SERVICE BULLETIN

BULLETIN #: **218**

MODEL: ALL BC GENERATOR MODELS

SUBJECT: INTEGRAL CONTROLLER PN#035981
(DC BATTERY CHARGER)

BELOW ARE ILLUSTRATIONS OF THE OLD AND NEW CONTROLLER WITH ELECTRICAL CONNECTIONS.

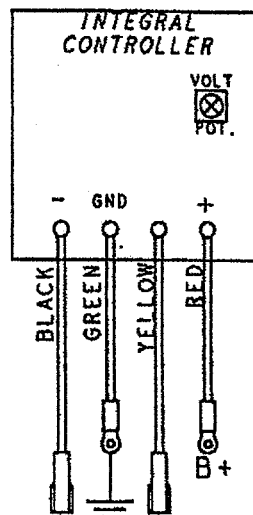
THE INTEGRAL CONTROLLER HAS BEEN CHANGED FROM A FOUR LEAD CONNECTION CONTROLLER TO A THREE LEAD CONNECTION CONTROLLER WITH SPADE TYPE TERMINALS. ONE TERMINAL HAS A DOUBLE-LEAD CONNECTOR.

BOTH STYLE CONTROLLERS ARE INTERCHANGEABLE.

THE NEW STYLE CONTROLLER WILL REMAIN UNDER THE SAME PART NUMBER #035981. THE PART NUMBER WILL BECOME A KIT THAT WILL INCLUDE THE ELECTRICAL LEADS THAT WILL ALLOW IT TO REPLACE THE OLD STYLE.
